# Thorndon Connections cycleway audit – safety and accessibility

30% design audit

Report prepared for

November 2022

Figure 4-1: Aitken St driveway

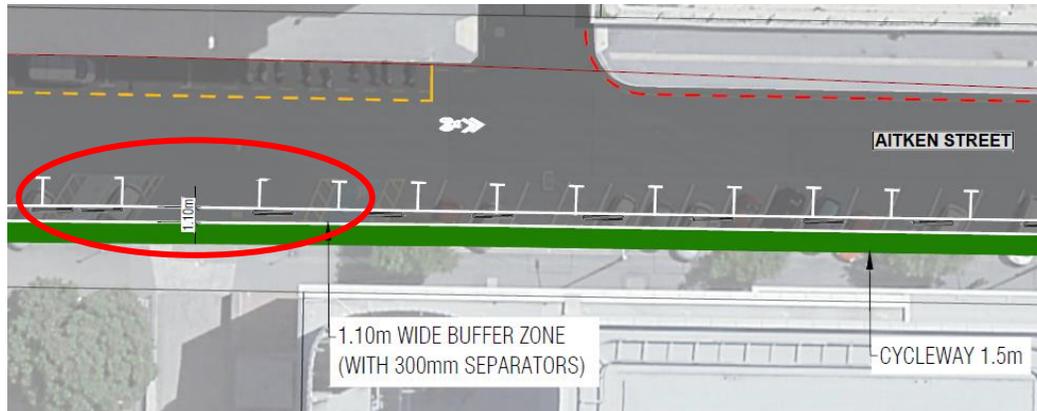
The safety issue is the parallel parking on Aitken St is too close to the driveway (Figure 4-1).

Probability of crash occurring	Likely
Expected crash severity	Minor injury
<b>Primary treatment recommendations:</b>	
4.3.1	Increase parking setbacks to driveway to comply with CNG <a href="#">Technical Note on separated cycleways at side roads and driveways</a>
<b>Supporting treatment recommendations:</b>

The crash type expected is conflict between a motor vehicle entering the driveway and a cyclist on the cycleway, due to the driver’s view of the cyclist being blocked by parked cars. The risk factors are the high parking occupancy along Aitken St and the assumedly high turning volumes into the driveways.

Figure 4-3: Areas of mixing lane where merging is allowed vs excluded, based on vehicle tracking

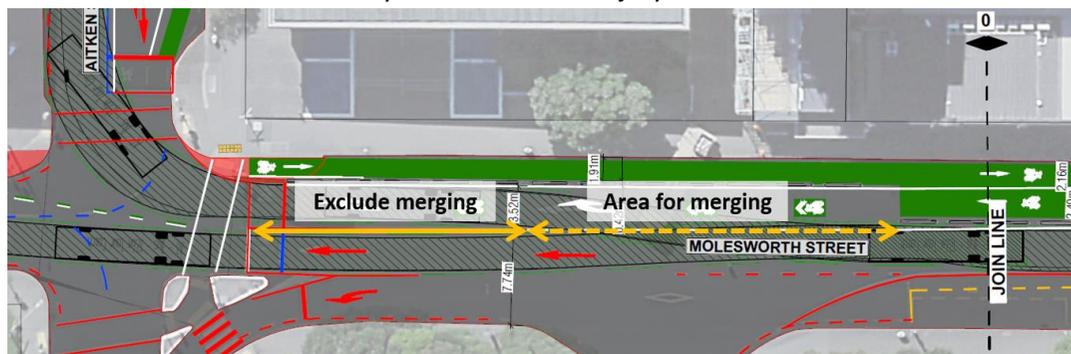
4.6.1	Restrict the merge area of the mixing lanes to lower vehicle entry speeds (see Figure 4-3). E.g. introduce a buffer between the mixing lane and adjacent through-lane and add a line of flexi-posts extending from the limit line.
-------	--

There is currently little available NZ guidance on the design of mixing lanes, however ViaStrada are currently working on a technical note for Waka Kotahi on the subject. It is expected that cyclist volumes will be high in these locations, as are traffic volumes; given also that mixing lanes are not common in Wellington, the probability of a crash occurring is likely. Given that motor vehicles are expected to be travelling around 30 km/h, crashes that do occur would likely result in serious injury.

<b>Responses:</b>	
<b>Designer</b>	<ul style="list-style-type: none"> <li>Restricting merge area at Riddiford St/ Mein St was trialled for the Newtown Cycleway which was not well received by the public. As a result no change to merge length at Murphy St/ Tinakori Rd/ Park St is proposed, as noted above at Aitken St/ Hill St/ Molesworth St, the shared left turn lane will be replaced with a separated cycleway.</li> </ul>
<b>Safety Engineer</b>	<p>Agree with Designer’s response.</p> <p>Merging behaviour at this location should be included in the Monitoring Plan.</p>
<b>Proposed action</b>	Designer to update in 90% designs
<b>Client decision</b>	Accept the proposed action – to include monitoring of merging as part of the monitoring plan

**Figure 4-4: cycleway transition to mixed traffic between bus stop and pedestrian crossing**

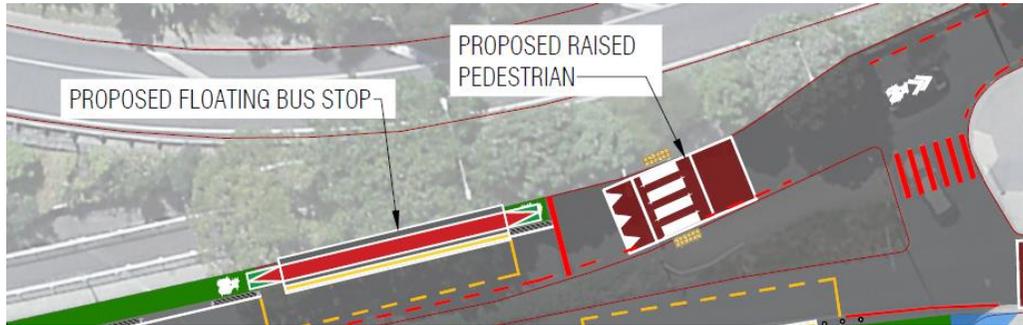
The safety issue is southbound cyclists on Murphy St transitioning from the cycleway to mixed traffic immediately after the floating bus stop (see issue 4.7) and immediately before the new raised pedestrian crossing.

The crash type expected is conflict between a cyclist and a motor vehicle.

The risk factors include the proximity of the three conflict points, which increases the cognitive load on drivers and cyclists, the lack of sharrows at the merge location (it is not possible to provide these due to the bus stop and the pedestrian crossing) and the potential for drivers to be distracted looking for pedestrians at the crossing rather than cyclists at the merge point.

Probability of crash occurring	Unlikely
Expected crash severity	Minor injury
<b>Primary treatment recommendations:</b>	
4.8.1	Shift the bus stop northwards, so a merge can be established prior to the pedestrian crossing (this may also help addressing issue 4.7).
4.8.2	OR continue the cycleway past the pedestrian crossing and merge downstream.
<b>Supporting treatment recommendations:</b>	
4.8.3	As well as providing sharrows at the merge location, provide sharrows just prior to the merge, to alert drivers.
4.8.4	Put sharrows in green boxes, to emphasise the merge to mixed traffic.

<b>Designer</b>	Agree, stop box to be shifted further north and add sharrow at merge location (the location of the stop box will be limited by the need to retain the current shelter in its location).
-----------------	---

Figure 4-6: void space on Aitken St approach

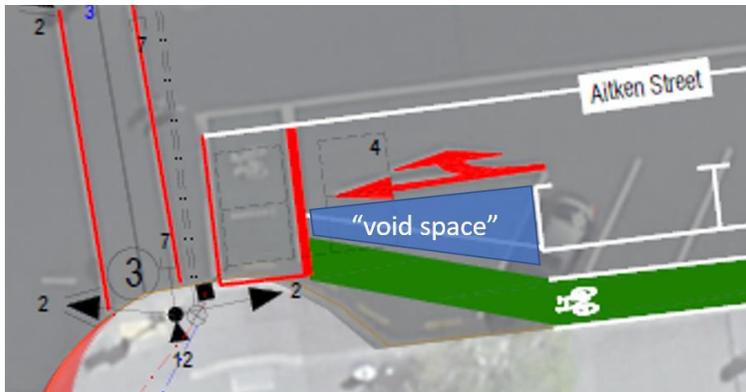
The plans indicate “right-turning cyclists from Aitken St and Hill St to filter right turn”; however, there is little space in the intersection for right-turning cyclists to wait free from the path of parallel and opposing through motor vehicles.

The risk factors for the Hill St approach include the lack of right-turning vehicles from this approach (since Molesworth St is one-way) and therefore no waiting right-turners in the intersection to “shelter” cyclists. Also, parallel through-traffic will likely err towards the right side of the lane, due to the bus stop on the departure side.

The risk factors for the Aitken St approach include right-turning cyclists having to get past the parallel through-traffic, as they are originating from a kerbside cycle lane. This is complicated by the taper on the cycle lane after the termination of the parking – drivers may use the “void space” (see Figure 4-6) to form two queues. Also, right-turning cyclists will want to wait a shorter distance into the intersection than right-turning drivers, because the cycle lane on Molesworth St is on the right-hand side.

| 4.17.2 | Offset the Aitken St and Hill St approach lanes and provide a pocket right-turn cycle lane with advanced stop line on Hill St.  |

<ul style="list-style-type: none"> <li>Demand for right turn from Hill Street is expected to be very low as vehicles on Tinakori Road from the north or south can use either Mulgrave Street or Bowen Street respectively to access the Bunny Street / Lambton Quay area. Furthermore, any provision would need a separate phasing creating LOS issues for bikes and buses and would potentially create confusion for other vehicles.</li> </ul>
<b>Safety Engineer</b>	Agree with Designer’s response.  Cycle right turn demand from Hill Street to be monitored, and further mitigation if necessary.
<b>Proposed action</b>	Monitor right turn demand as proposed above. Conduct cyclist count
<b>Client decision</b>	Accepted

**Figure 5-1: Lane markings at 61 Molesworth area**

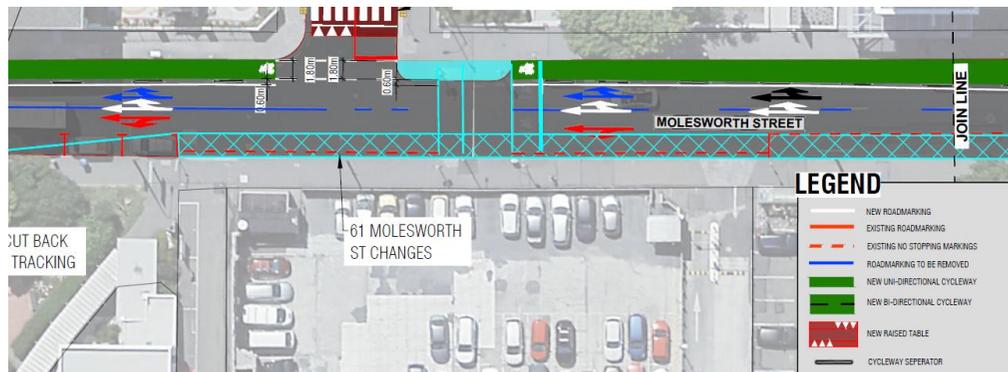
The design colour coding suggests existing shared through / left-turn lane to be retained, and through / right-turn lane to be shifted over, however this does not properly reflect the intention of there being one lane only in this section.

5.4.1	Modify the lane arrows to show there is only one lane in this section.
-------	--

<b>Designer</b>	<ul style="list-style-type: none"> <li>Agree to rationalise in 90% designs</li> </ul>
<b>Safety Engineer</b>	Agree with CAT and Designer’s response.
<b>Proposed action</b>	Designers to update in 90% designs.
